SUBJECT: ISSUANCE OF ORDER MODIFYING LICENSE NO. R-125 TO CONVERT FROM
HIGH- TO LOW-ENRICHED URANIUM (AMENDMENT NO. 12) - UNIVERSITY OF
MASSACHUSETTS LOWELL (TAC NO. M86788)

ORDER MODIFYING FACILITY OPERATING LICENSE NO. R-125

REPLACEMENT PAGES FOR TECHNICAL SPECIFICATIONS

APPENDIX A
TO
FACILITY OPERATING LICENSE NO. R-125
TECHNICAL SPECIFICATIONS
FOR THE
UNIVERSITY OF LOWELL

Figure 2.1 T.S. Power-Flow Safety Limit Curve

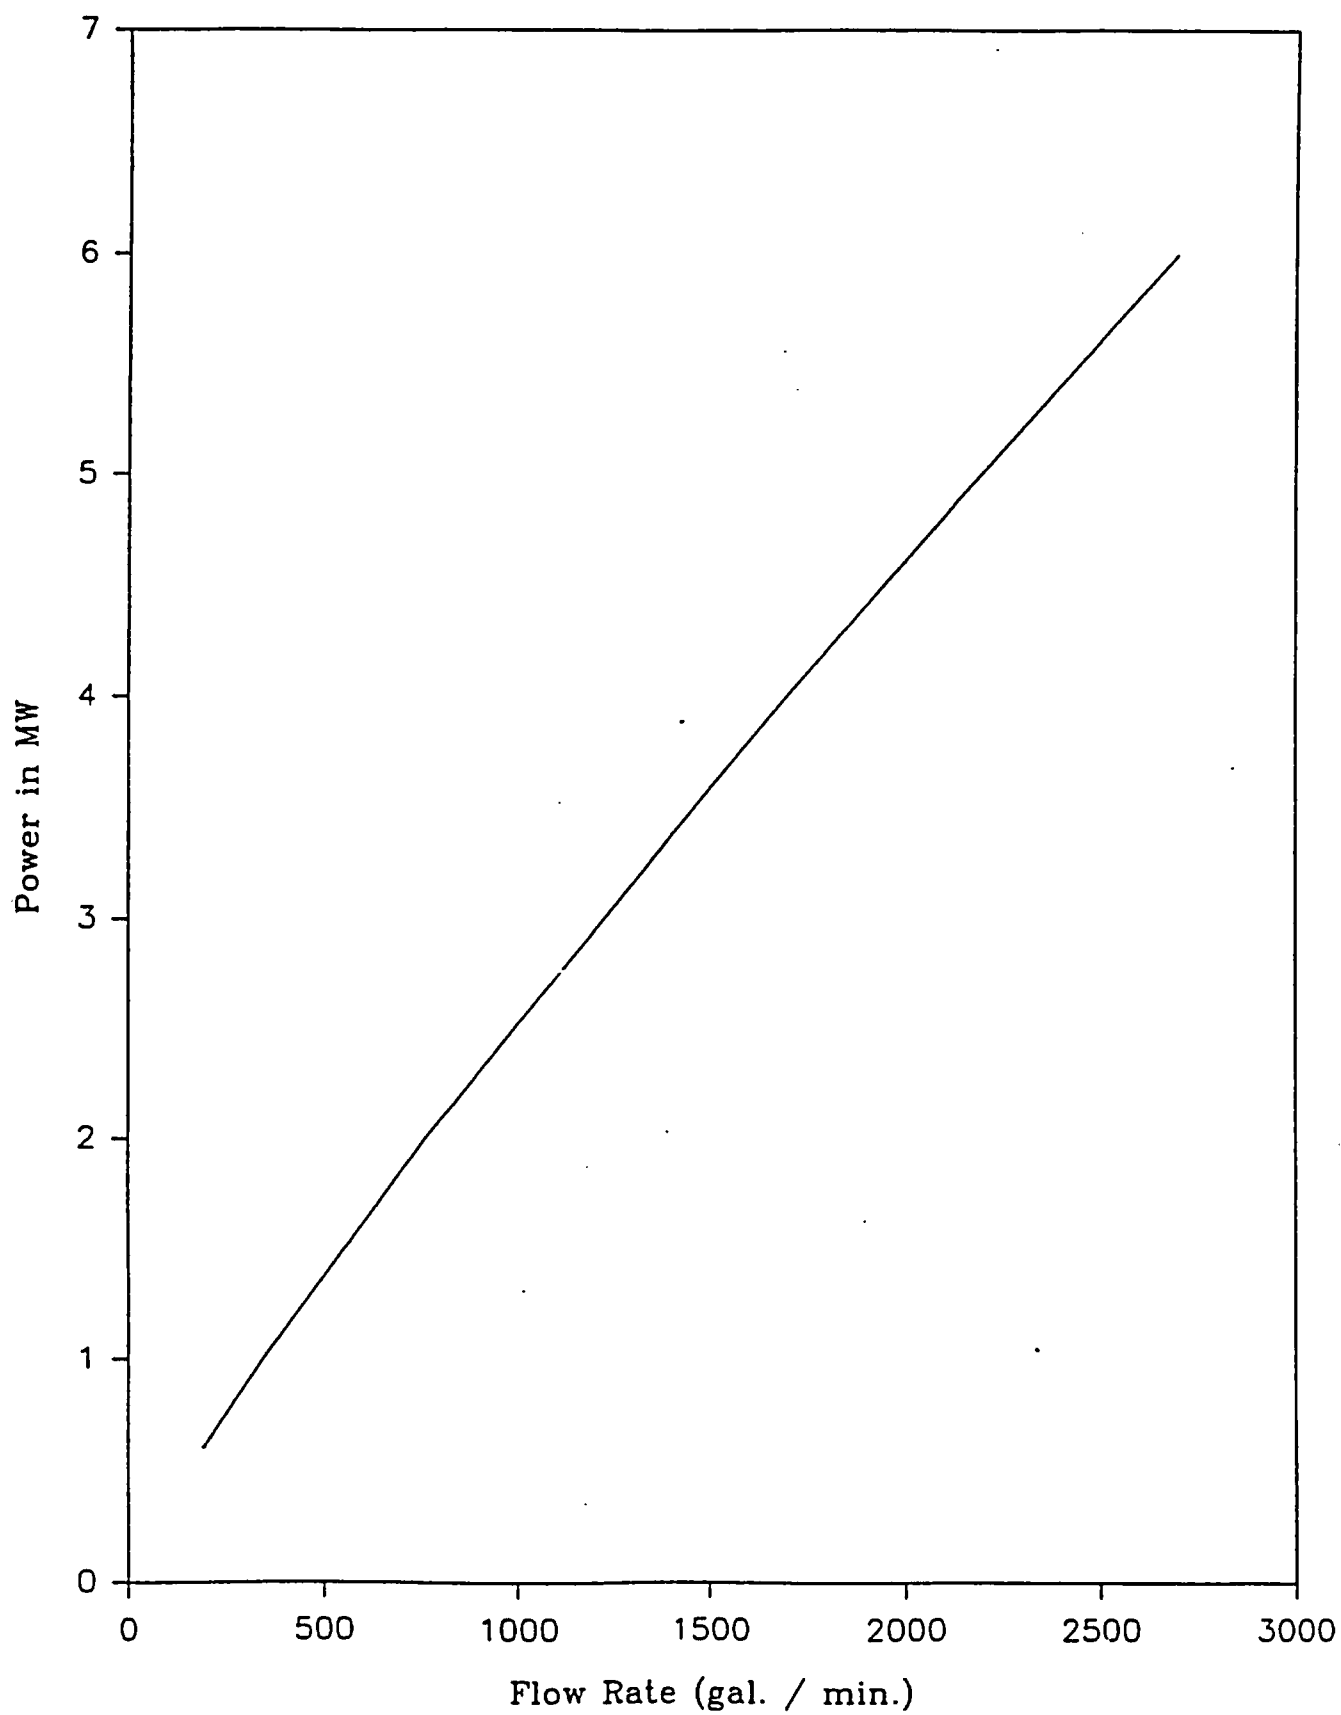
The licensee proposed to change the safety limits for forced flow and add Figure 2.1, which will replace existing TSs 2.1.1.1 and 2.1.1.2. Figure 2.1 represents the relationship between reactor thermal power and reactor coolant flow rate and indicates the flow necessary to prevent ONB for a given power level. Since Figure 2.1 is a more comprehensive way of indicating this safety limit, the staff finds this TS change acceptable.

1. The combination of true values of reactor thermal power (P) and reactor coolant flow rate (W) shall not exceed the limits shown in Figure 2.1 T.S under any operating conditions. The limits are considered exceeded if the point defined by the true values of P and W is at any time above the curve shown in Figure 2.1 T.S.
2. The true value of the pool water level (L) shall not be less than 24 feet above the center line of the core.
